SEARSBURG / WILMINGTON

Drainage Sheet 3 of 27

SEARSBURG - WILMINGTON
NH-F010-1(18)

~~182+00~~ 181+73
NEW 12" CSP x 42' L.F.
(SEE BOOK 7, pg 151)
see Dr. Bk 2A pg 38 and Item Detail and Dr. Sh. #1 of 3

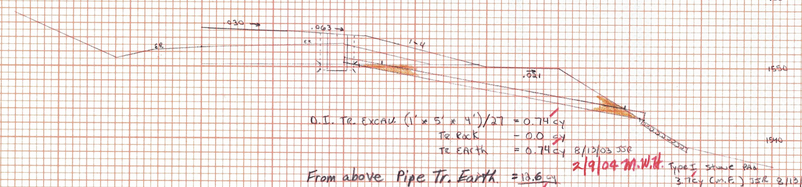
Pipe installed 8/13/03 JSR

Pipe Tr. Excavation 110' x 3.1 x 1/27 = 12.6 cy
Tr. Rock = 0.0 cy
Tr. Earth = 12.6 cy 8/13/03 JSR
2/10/04 M.W.H.

O.I. Tr. Excav. (1' x 5' x 4')/27 = 0.74 cy
Tr. Rock = 0.0 cy
Tr. Earth = 0.74 cy 8/13/03 JSR
2/9/04 M.W.H.

From above Pipe Tr. Earth = 13.6 cy
Total 13.9 cy

Type I Stone Pad
3.7 cy (C.F.) JSR 8/13/03
10' x 10' x 1' M.W.H. 2/9/04

172+12
NEW 15" CPEP
see Item Detail + Drainage Sheet 1 of 3
see BK. #2, Pg. 154

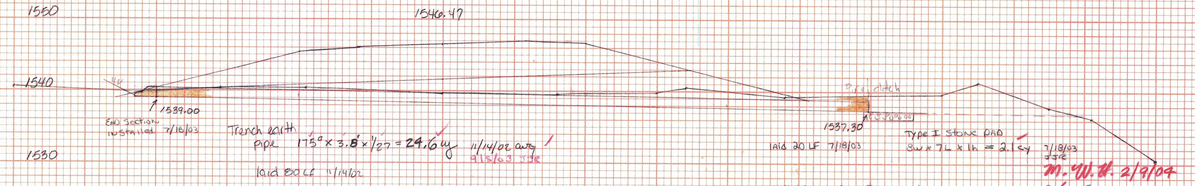
Trench width
pipe 115' x 3.8' x 1/27 = 24.6 cy 11/14/02 Carry
9/15/03 JSR
laid 80 LF 7/18/03

laid 30 LF 7/18/03

Type I Stone Pad
8' W x 7' L x 1' D = 2.1 cy 7/18/03 JSR
M.W.H. 2/9/04

28.6
204.30 Gr. Backfill Structures
Pipe - $((100' \times 3.8' \times 2.5') - (\frac{\pi 1.5^2}{4} \times 100))/27 = \cancel{37.9}$ cy 7/18/03 JSR
2/10/04 M.W.H.
4-2-04 R.A.
